UPDATE CHANGE NOTIFICATION # 16361Generic Copy

Issue Date: 16-Jul-2010**TITLE:** Marking and Ordering Information Update for Gresham die based 2Kb I²C Serial EEPROM Devices (CAT24C02)**PROPOSED FIRST SHIP DATE:** 01 Aug 2010**AFFECTED CHANGE CATEGORY(S):** CAT24C02, Gresham Die (all packages, all temperatures)**ADDITIONAL RELIABILITY DATA:** n/a**SAMPLES:** Contact your local ON Semiconductor Sales Office**FOR ANY QUESTIONS CONCERNING THIS NOTIFICATION:**Contact your local ON Semiconductor Sales Office or Denisa Stefan
<denisa.stefan@onsemi.com>**NOTIFICATION TYPE:**ON Semiconductor will consider this change approved unless specific conditions of acceptance are provided in writing within 30 days of receipt of this notice. To do so, contact <quality@onsemi.com>.**DESCRIPTION AND PURPOSE:****Marking Update:**Package marking for 2Kb I²C Serial EEPROM devices fabricated with Gresham die (presently offered under OPNs terminated with 'A') will be updated, as compared to the format previously published in FPCN 16361, in order to align the marking for these devices to the improved marking format most recently announced for 4Kb to 64Kb I²C devices fabricated with Gresham die (FPCN 16476).

SOIC (W)

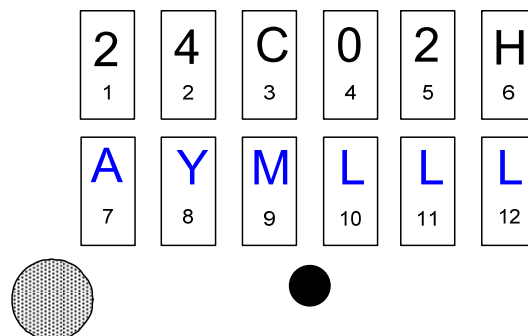
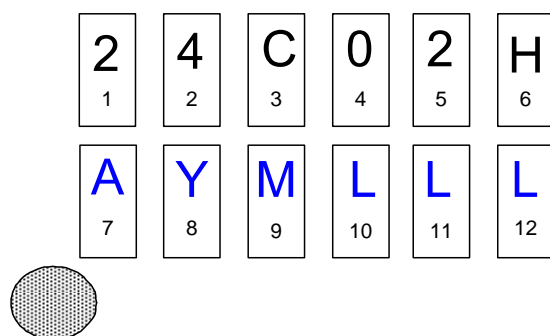
CAT24C02 Gresham die based package marking, before and after August 1st, 2010

Before August, 2010 (FPCN#16361)

After August, 2010

PDIP (L)

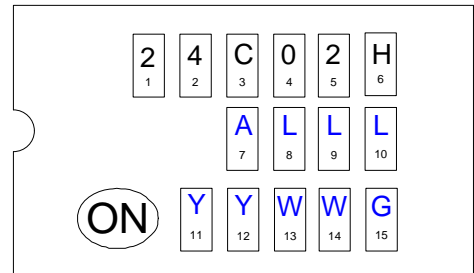
Before August, 2010 (FPCN#16361)

After August, 2010

TDFN8 - 2x3 (VP2)

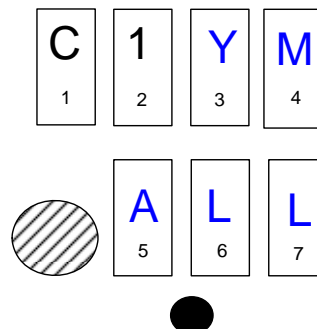
C 1	1 2	A 3
L 4	L 5	L 6
	Y 7	M 8

C 1	1 2	T 3
A 4	L 5	L 6
	Y 7	M 8

C 1	1 2	A 3
L 4	L 5	L 6
	Y 7	M 8

C 1	1 2	U 3
A 4	L 5	L 6
	Y 7	M 8

MSOP (Z)

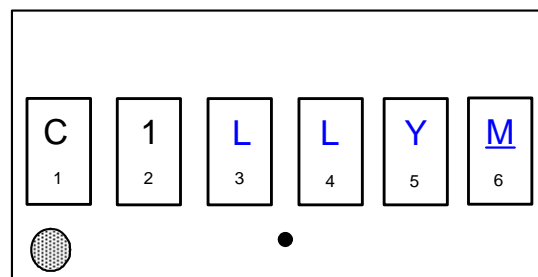
Before August, 2010 (FPCN#16361)

After August, 2010
